5 - 7 STATION ROAD, HAYLING ISLAND

MIXED-USE DEVELOPMENT

Transport Statement

PWPA/18/4652s

Internal Swept Path Analysis

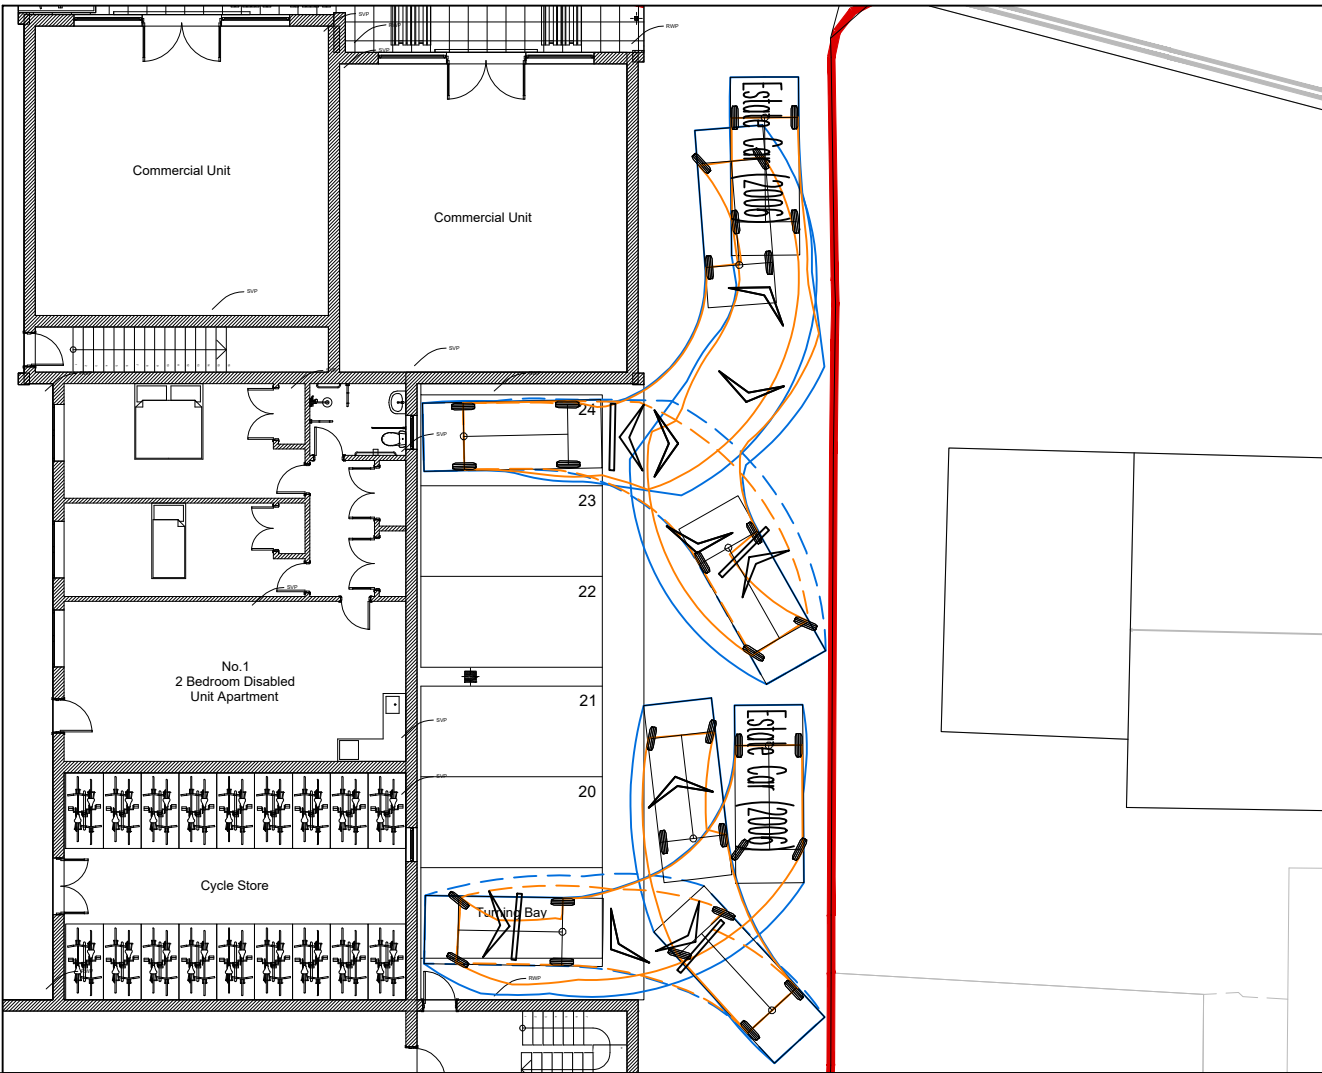
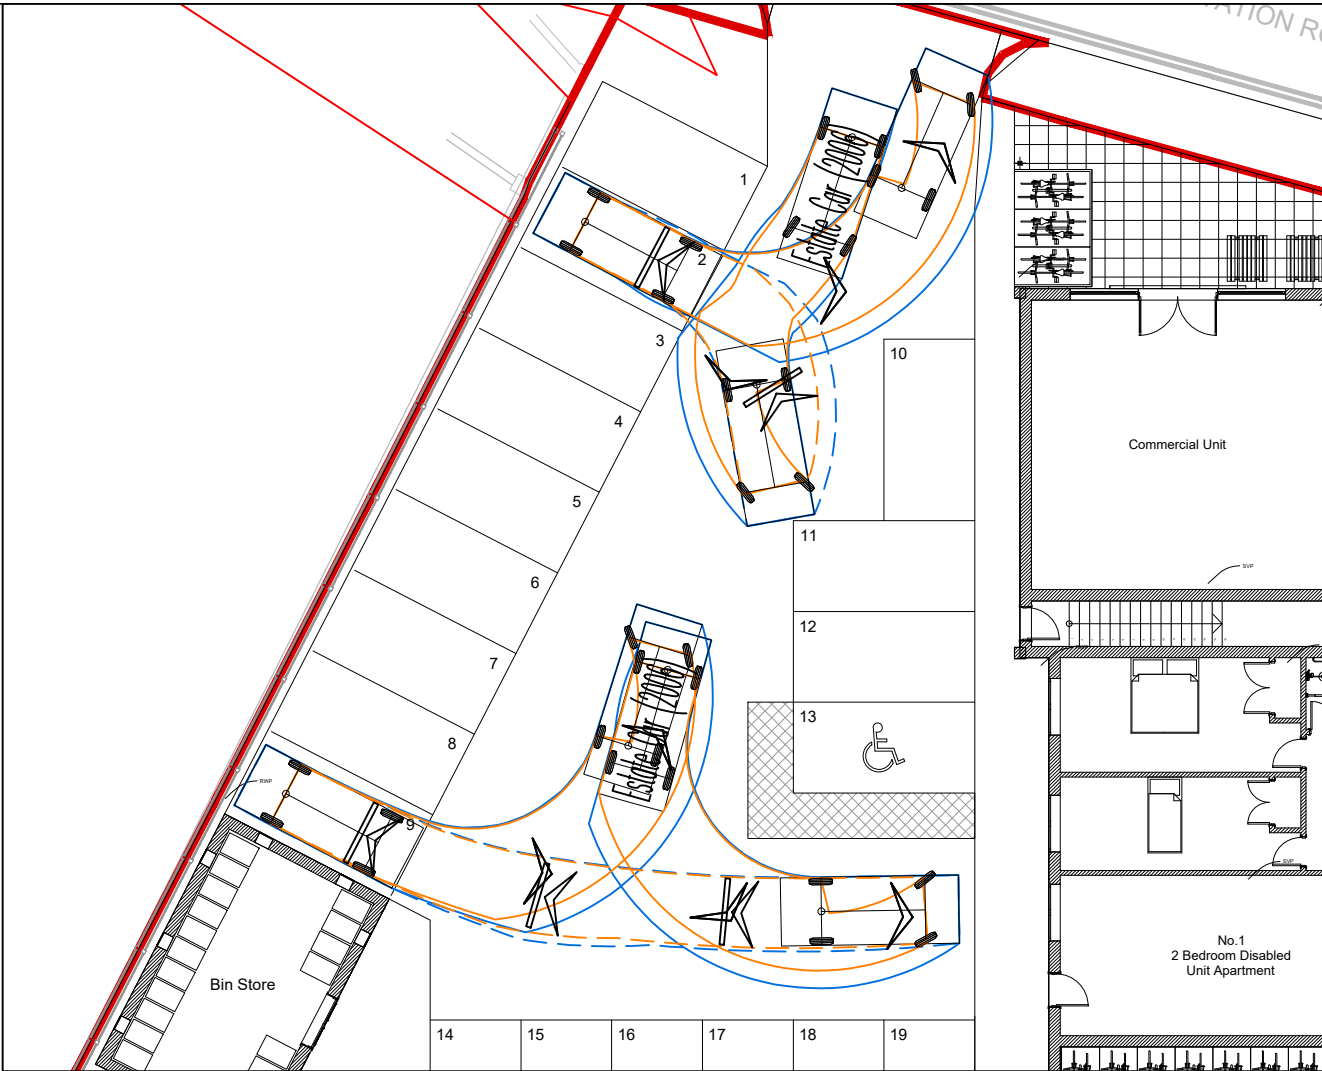
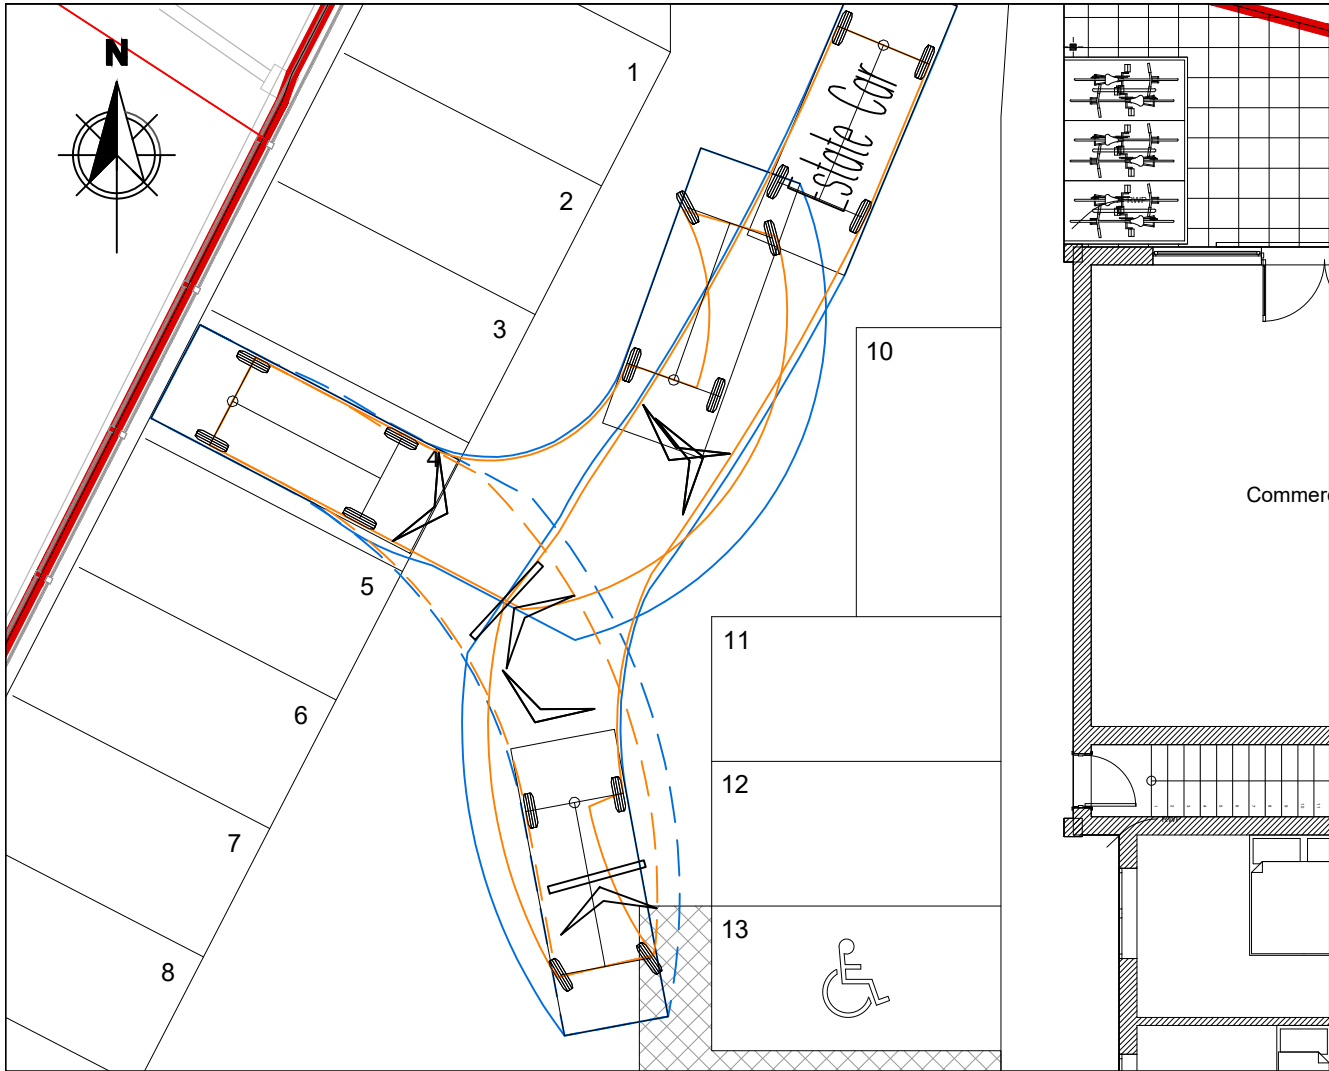
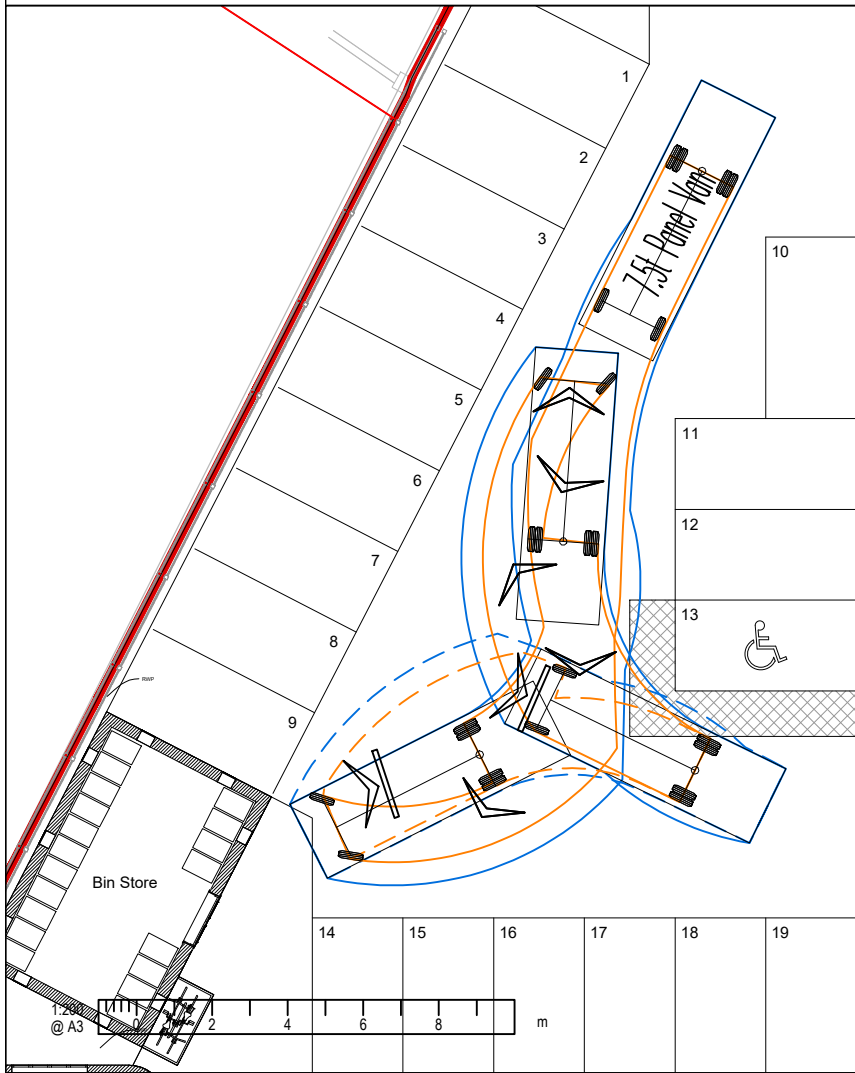
"While the quantum of parking is a matter for HBC as the local authority, the Highway Authority still provide comments on the layout of these parking spaces and their suitability in serving the development. Dimensions for a single car port are proposed at 2.4m x 4.8m which corresponds with Havant's SPD. A shortfall of 4 parking spaces for the business units and 4 for the apartments is proposed, with this shortfall to be accommodated by the adjacent public car park currently serving Hayling Park. A parking beat survey was undertaken on a Wednesday and Thursday at the following intervals: 01:00, 09:00 and 19:00.

Also - the tracking drawings fail to take account of the proposed planted island within the central courtyard, which will be important to break up the otherwise unrelieved hard surfacing in this area. They should therefore be redrawn to take account of this important landscape feature."

2.5.3 As shown in **Figure 2.3**, the revised car parking layout provides 24 unallocated spaces for the residential units in accordance with HBC's standards. A vehicle swept path analysis has been undertaken demonstrating car parking manoeuvres in **Drawing 2018/4652/004**.

3.1.3 The planted island has been removed from the proposed layout.

Drawing Status	FINAL		
Client	PWP Architects		
Project	5 - 7 Station Road, Hayling Island		
Drawing Title	Heron Autos Access		
Scale	1:200	Date	Sept 19
Drawn By	SMO	Checked By	ALB
Drawing No.	2018-4652-005		Rev.
		-

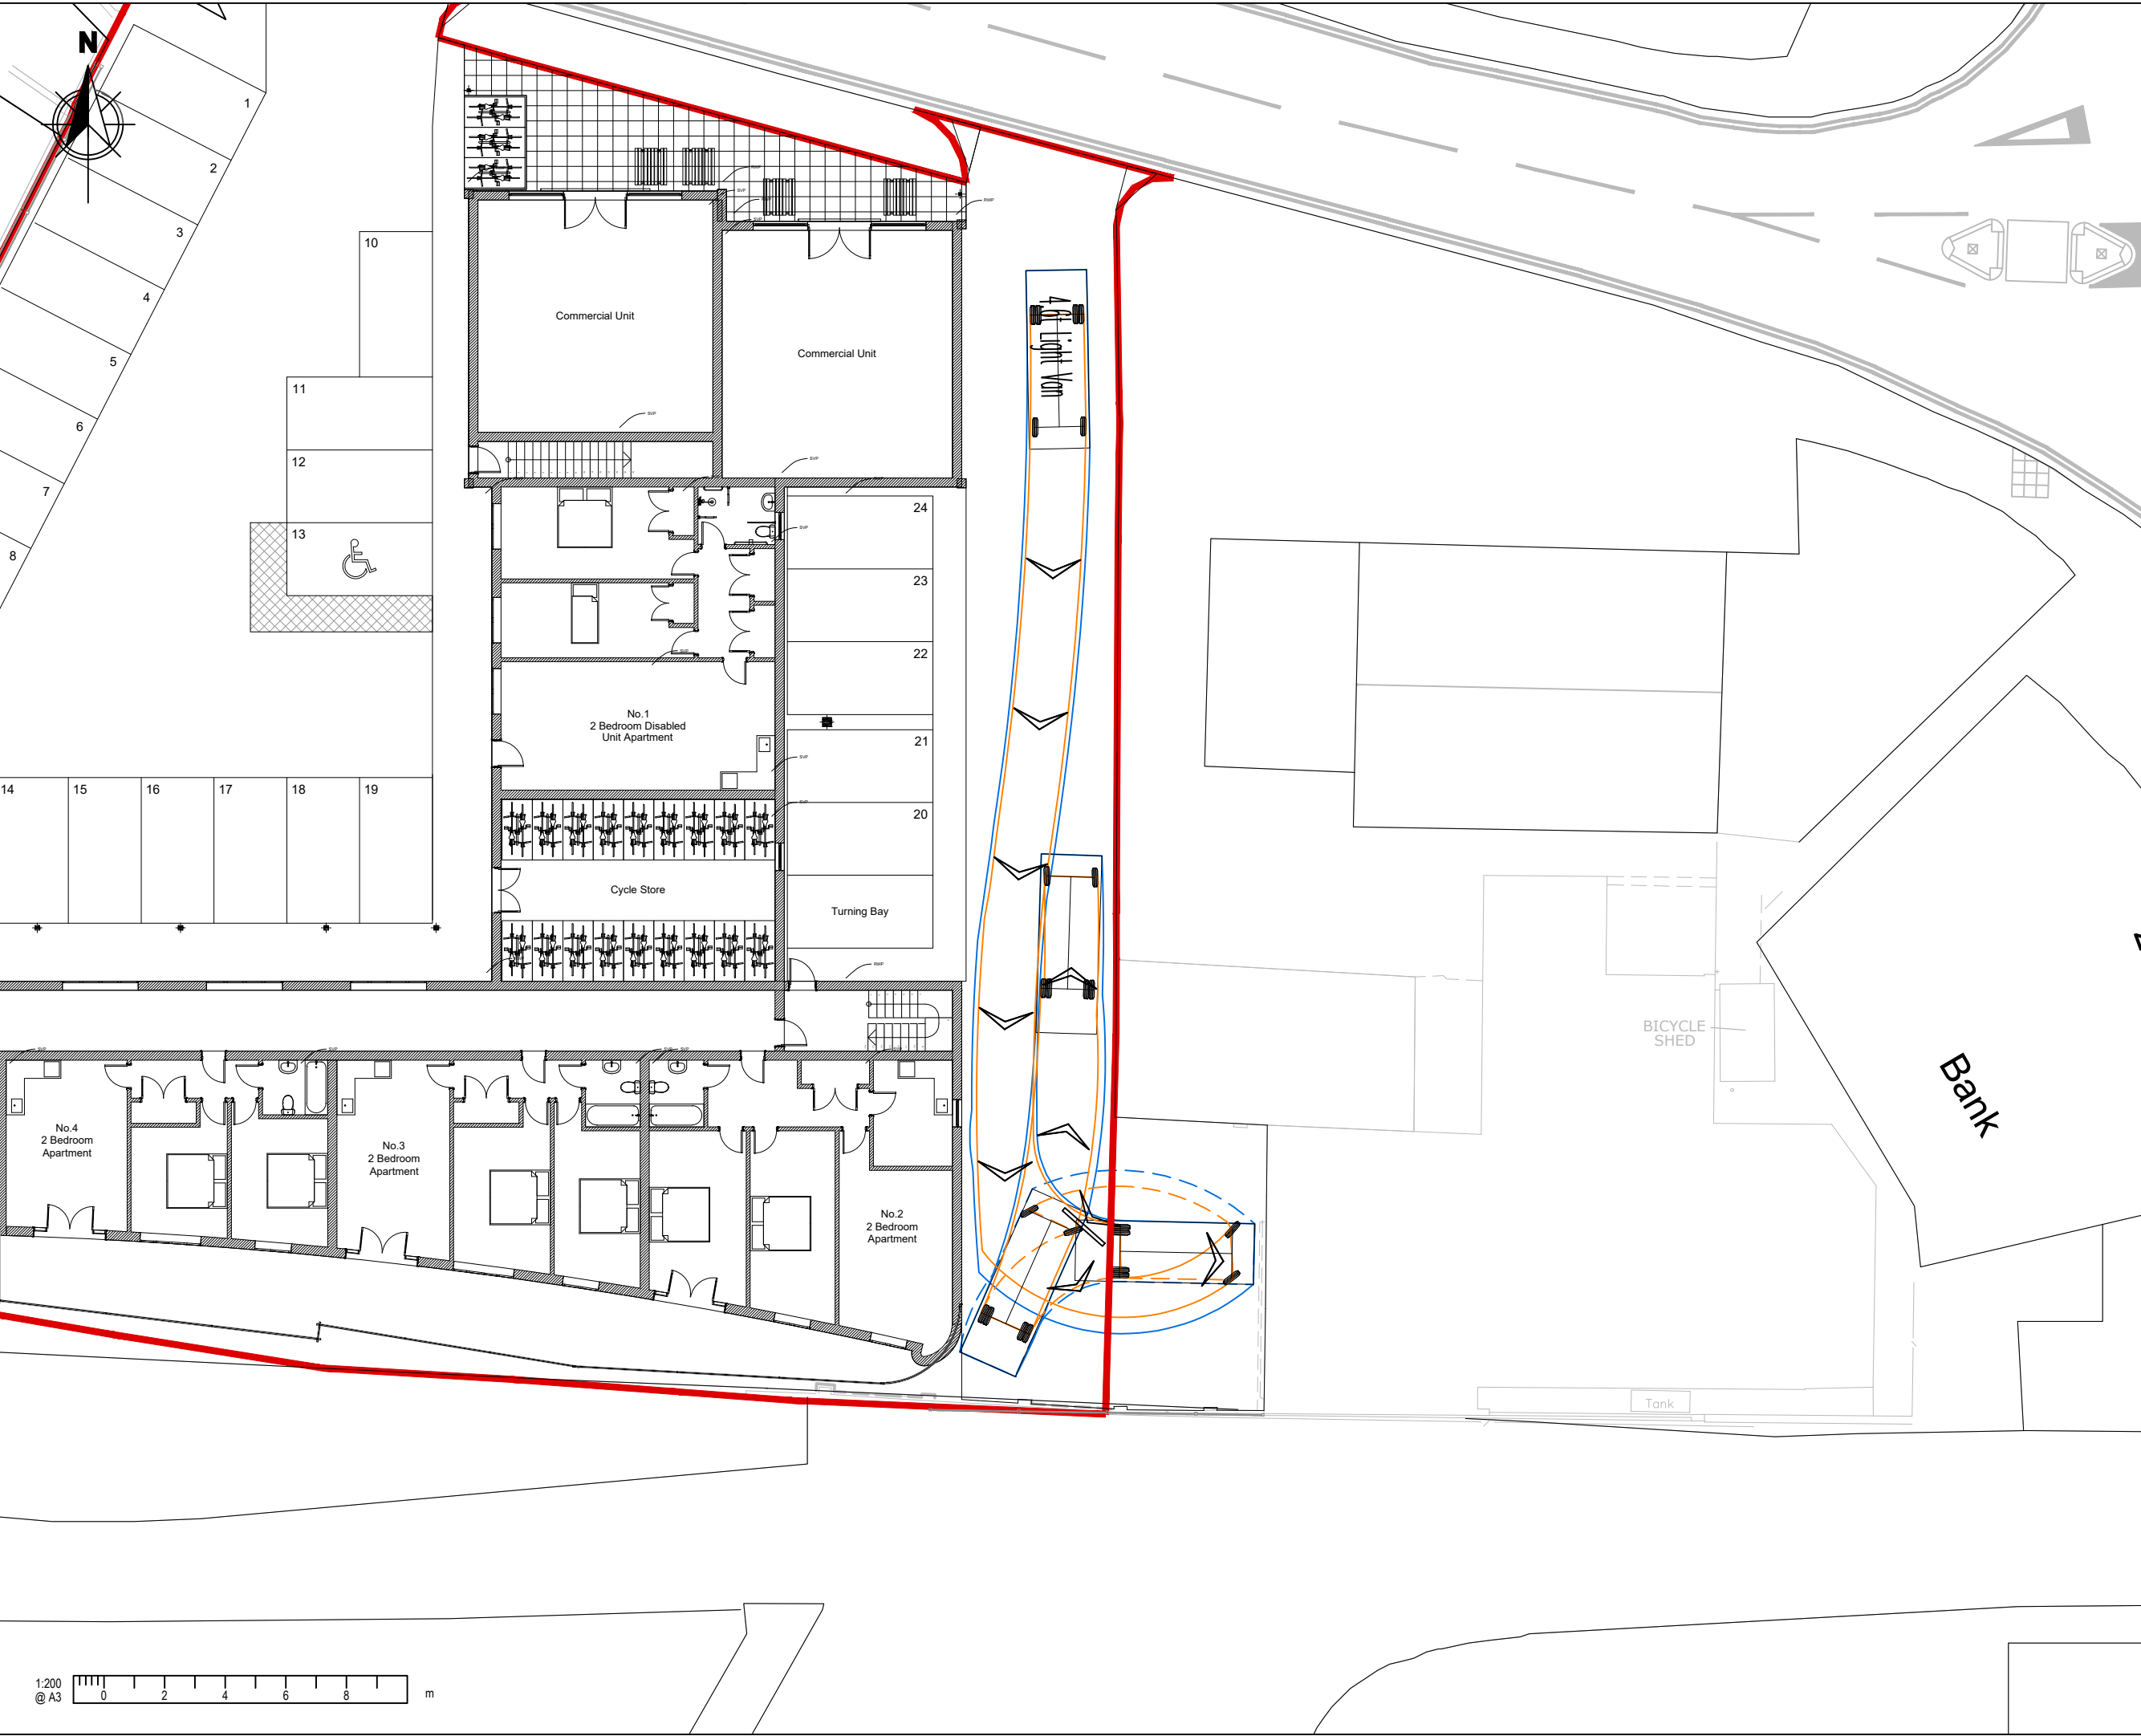
"whilst no issues are raised by the Highways Authority, I note that tracking has not been undertaken for the eastern access for anything other than a family car. This ignores the existence of the Heron Autos automotive premises to the south east of the site, which will share the eastern access. How is it intended that servicing of this industrial unit will take place from the eastern access? I am concerned that the proximity of the footprint of the building to the eastern boundary will preclude the satisfactory operation of this established business (as well as having amenity implications, discussed below).

3.1.2 A vehicle swept path analysis has been undertaken demonstrating a delivery vehicle accessing the Heron Auto site and performing turning manoeuvres in **Drawing 2018/4652/005**.
